Reference: Response to Peer Review Comments  
Application for Site Plan Review, Case #9-20  
150 Tihonet Road PV+ES Project  
Wareham, Massachusetts  
B+T Project No. 1833.112

On behalf of the Applicant, Borrego Solar Systems, Inc. (BSSI), Beals and Thomas, Inc. (B+T) respectfully submits this response to comments and associated revised plans for the above-referenced project in response to peer review comments by Charles L. Rowley, PE, PLS in a letter dated November 9, 2020, as well as associated Planning Board feedback during its November 9, 2020 hearing. For ease of review, peer review comments are indicated in *italicized* font, with our responses in regular font.

**C-6.0**  
 RED PINE LANE - SIGHT LINE

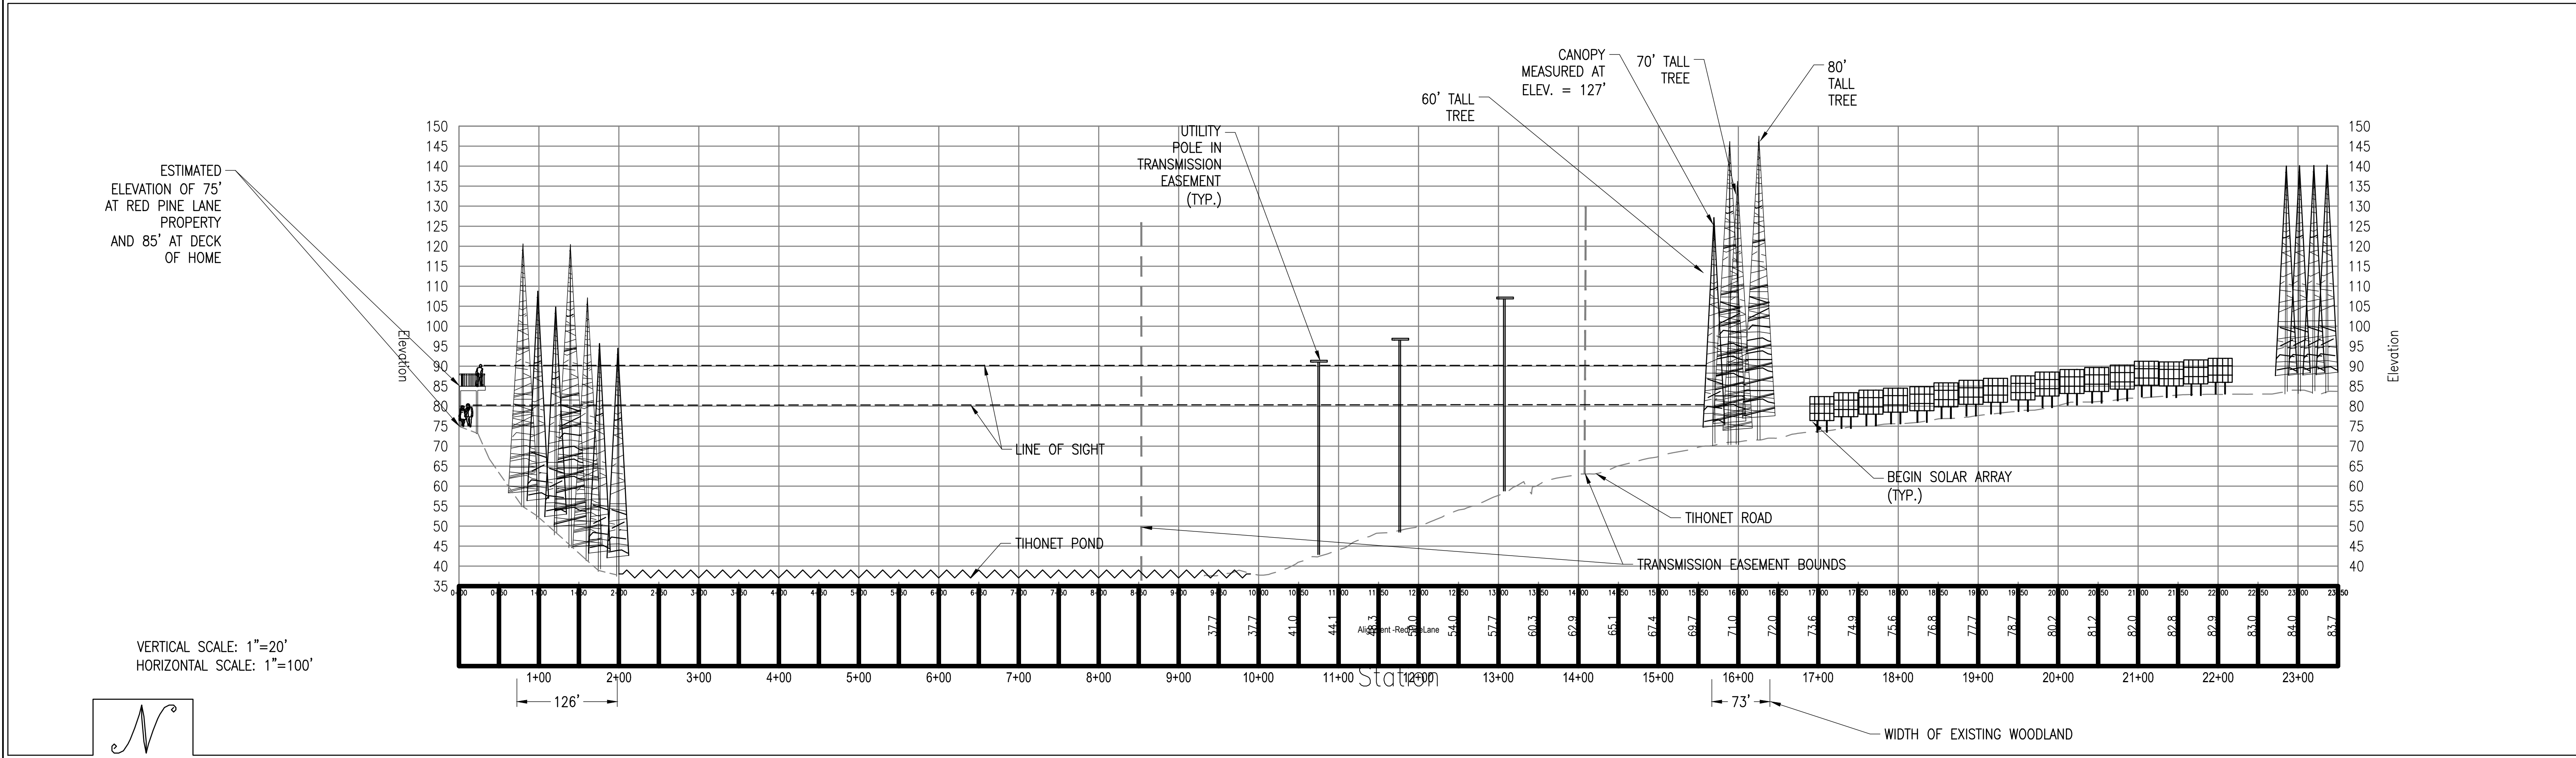
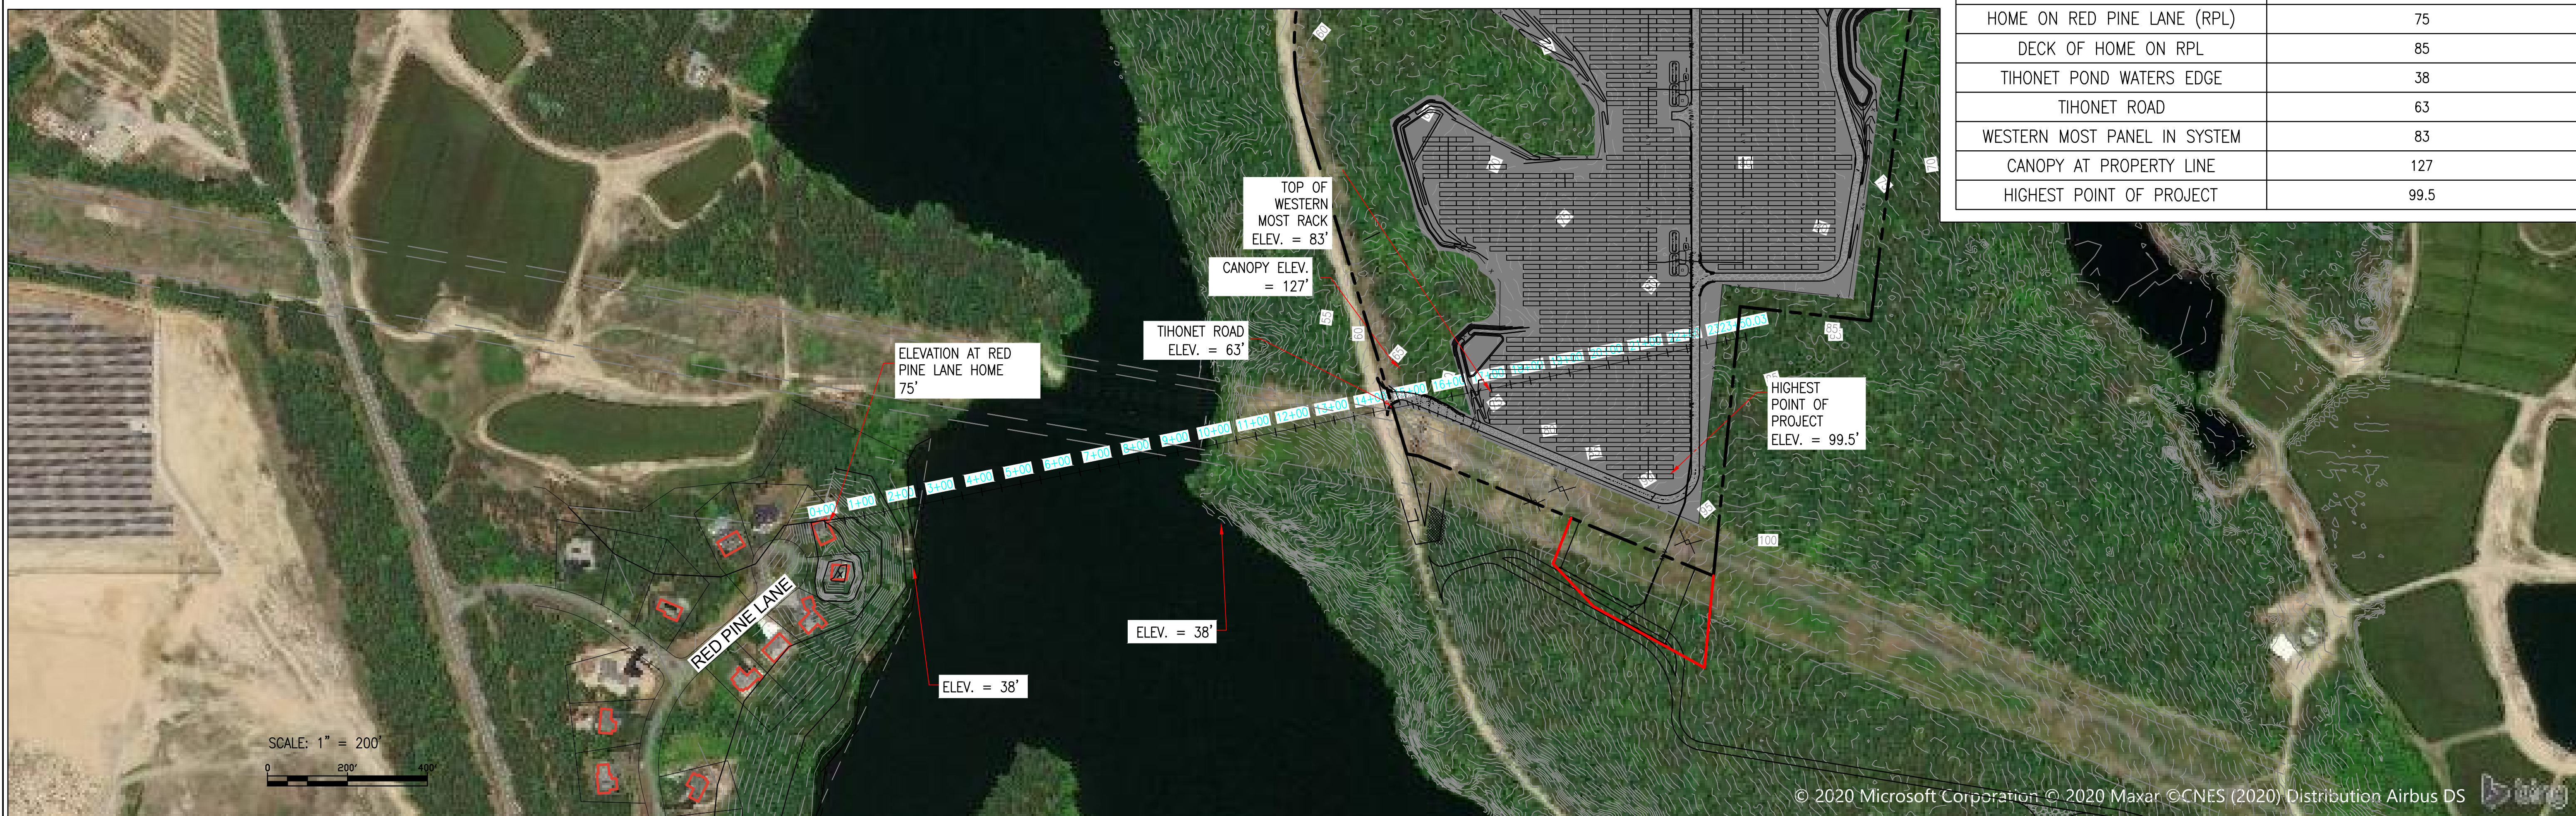
The Planning Board also expressed concern regarding potential views from the Red Pine Lane neighborhood to the project. Enclosed please find a profile view of the area discussed at the hearing, to document that the project will not be visible from the Red Pine Lane neighborhood.

LINE OF SIGHT – RED PINE LANE TO 150 TIHONET SOLAR	
ELEVATIONS OF KEY POINTS	
	APPROX. FEET
HOME ON RED PINE LANE (RPL)	75
DECK OF HOME ON RPL	85
TIHONET POND WATERS EDGE	38
TIHONET ROAD	63
WESTERN MOST PANEL IN SYSTEM	83
CANOPY AT PROPERTY LINE	127
HIGHEST POINT OF PROJECT	99.5
